NO: Sw - 158

PRODUCT: B3FS-4 series – Tactile Switch

TYPE: MODIFICATION – Lot Code Marking and Base Mold Gate change

B3FS-4 series Tactile Switch - Lot Code Marking and Base Mold Gate change

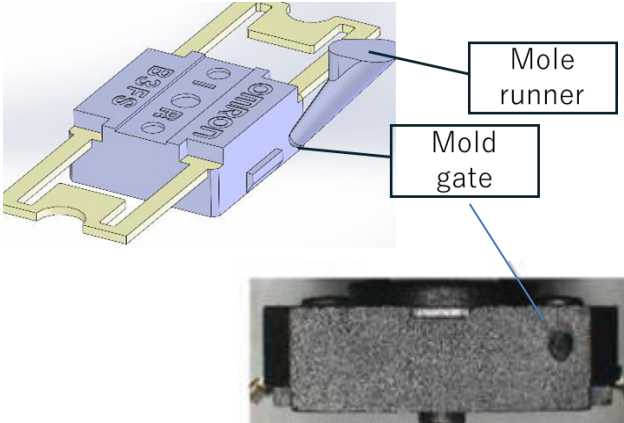
Before the change	After the change
Lot Code Marking Position: Top side on cover Number of digits: Two-digit notation Marking method: Engraving 	Lot Code Marking Position: On side of Base part Removed from top side on cover Number of digits: Seven-digit notation Marking method: Laser  Lot Code decoding: A : Day 01,02,03...30,31 B: Month 1,2,3,...X(10),Y(11),Z(12) C: Year (The last character of the year notation.) D: Code of Production site E: Management number F: Management number

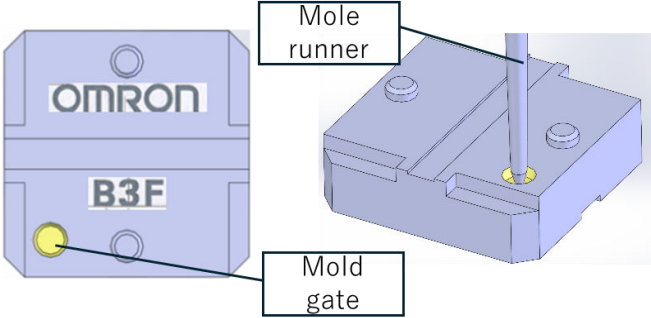
Before the change	After the change
Molded gate Position: On side of base 	Molded gate Position: On bottom of base  Note: Gate position subject to change.
